MT9085 Series ACCESS Master

Release Notes

Version 3.00

(Improvement Example 1)

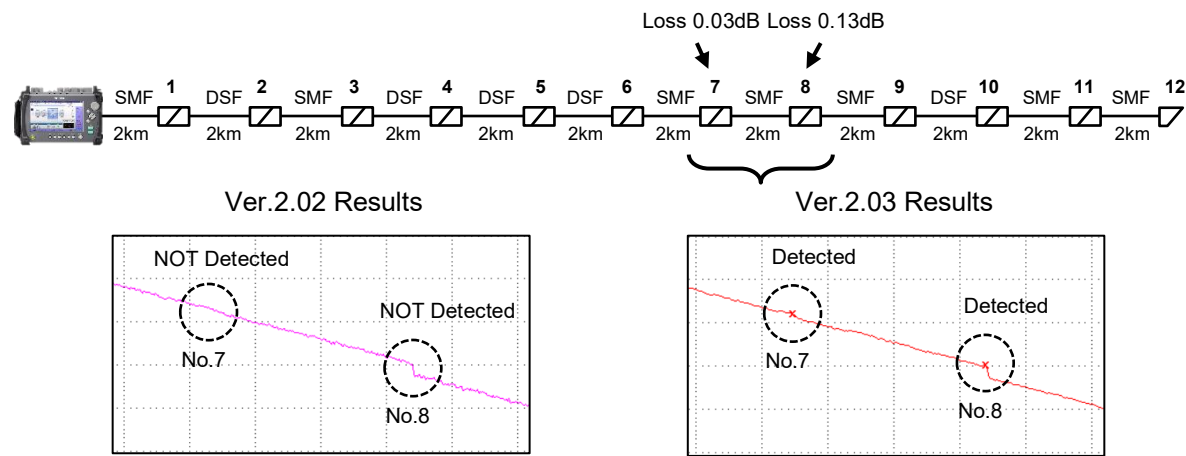
We have improved the detection rate of events with low connection losses or that are adjacent. Note that this improvement applies only when measuring using Ver 2.03. When reanalyzing the loaded trace file measured by Ver 2.02 or earlier versions, analyzed results are the same as those of Ver 2.02 or earlier.

Ver. 2.02 or earlier occasionally failed to detect such low loss events as shown below. Ver. 2.03 can detect these events.

(Improvement example 2)

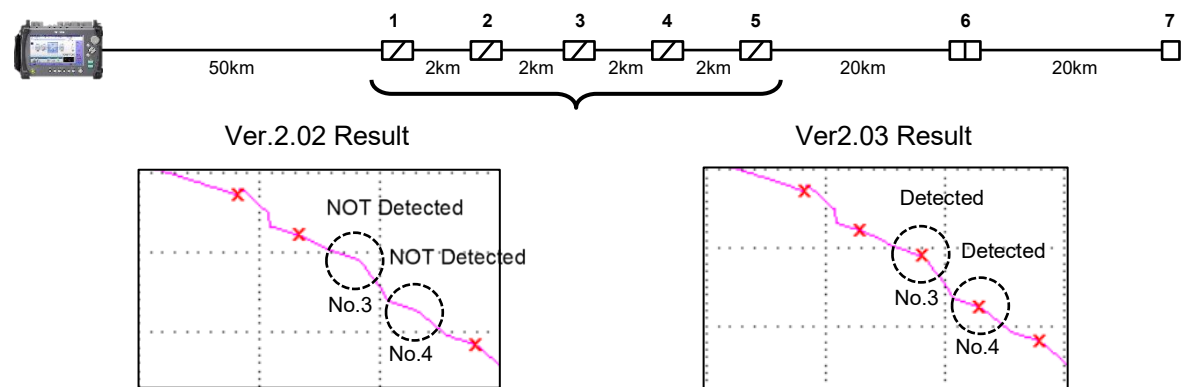
Ver. 2.02 or earlier occasionally failed to detect some of adjacent events existing in the long-distance fiber as shown in the figure below. Ver. 2.03 can detect these events.
